MITSUBISHI HEAVY INDUSTRIES, LTD.

Subject: MHI's Responses to US-APWR DCD RAI 598-4754 Revision 2

Responses to Request for Additional Information No. 598-4754 Revision 2

RAI NO.:NO. 598-4754 REVISION 2SRP SECTION:10.02 TURBINE GENERATORAPPLICATION SECTION:10.2DATE OF RAI ISSUE:6/15/2010

Fig.1 OVERSPEED TRIP DEVICE

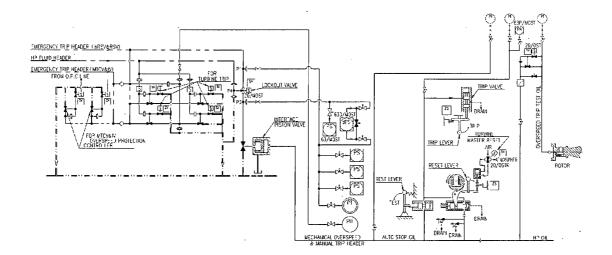
- The description of the turbine overspeed protection systems should clearly indicate what parts are shared. For example, shared air and hydraulic dump lines and components such as trip blocks, dump valves and reservoirs should be described in the DCD. For clarity, the response should include schematic diagrams that show these flow paths, applicable components, and valves being actuated (i.e., turbine stop, control, reheat stop, intercept, and extraction nonreturn valves).

- 10) Tier 2 Section 10.2.2.3.2.1 describes the emergency trip system. To facilitate the staff's understanding and review of this system, a simplified schematic should be provided for both the backup electric and mechanical overspeed trip systems (relates to RAI 10.2-05).

A schematic diagram which shows common parts of the turbine overspeed protection systems is provided on Fig.1. The electrical overspeed trip (EOST) detects rotation speed of the turbine shaft. In the event of reaching the setting point of the turbine speed, four (4) trip solenoid valves open to drain the emergency trip header fluid pressure and subsequently the main turbine stop, reheat stop, and extraction nonreturn valves are closed and then the turbine control and intercept valves are closed before turbine trip.

On the other hand, the mechanical overspeed trip (MOST) uses the interface piston valve for turbine trip. The interface piston valve is the key valve that connects the lubrication oil system and control oil system. It maintains the control oil pressure within the emergency trip header of the lubrication oil system during normal operation.

In the event that the speed of the turbine shaft goes up to the setting point of the MOST, the weight overcomes the spring force, actuate the MOST, and drain the autostop fluid of the manual trip header, which opens the interface piston valve to lead the control fluid within the emergency trip header to drain. After that the main turbine stop, reheat stop, extraction nonreturn valves are closed before control and intercept valves are closed, and subsequently leads to turbine trip.

Please refer to Response to the Response to question 1) of RAI 10.02-05. A simplified schematic for the backup electric and mechanical overspeed trip systems is shown in Fig.1.
